# ***SERVICE PROCEDURE***

**G-08503  
MAY 2008**

**SUBJECT:    SAFETY RECALL (U.S.)  
                  **BENDIX MV-3 DASH CONTROL VALVE on certain  
                  4000, 5000, 7000, 8000, 9000, and ProStar models  
                  built 1/15/2008 thru 2/7/2008.****

Figure 1. Bendix MV-3 Dash Control Valve

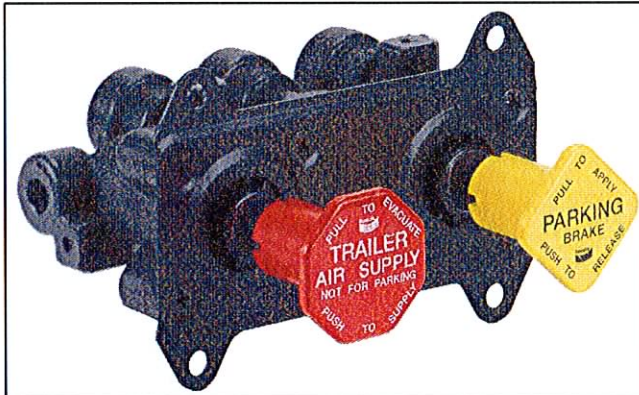
On vehicles equipped with a Bendix MV-3 dash control valve, the rubber double check valve may become lodged in the valve body. In the event of a primary reservoir failure, air pressure may leak past the lodged double check valve thereby depleting the secondary reservoir, causing reduced ability for modulating the service emergency brakes.

1. Park the vehicle on a hard level surface; set the parking brake; turn the engine off; and block the wheels to prevent the vehicle from moving either forward or backward.
2. Locate Bendix MV-3 dash control valve. Valve is shown in Figure 1. Remove dash panel access cover(s) to expose valve body cover plate. Remove valve mounting screws.

3. With air lines still connected, pull the valve through dash panel opening so that the valve body date code may be inspected. Determine if the valve is applicable to the recall using the attached Bendix® MV-3® Dash Control Valve Recall Campaign Identification Guide.

4. If the recall is not applicable to the valve, no further service is required. Reinstall valve and access cover(s) in dash panel.
5. If the recall is applicable to the valve, replace the valve using attached Bendix MV-3 installation instructions. Check for any air leaks. Reinstall access cover(s) in the dash panel.
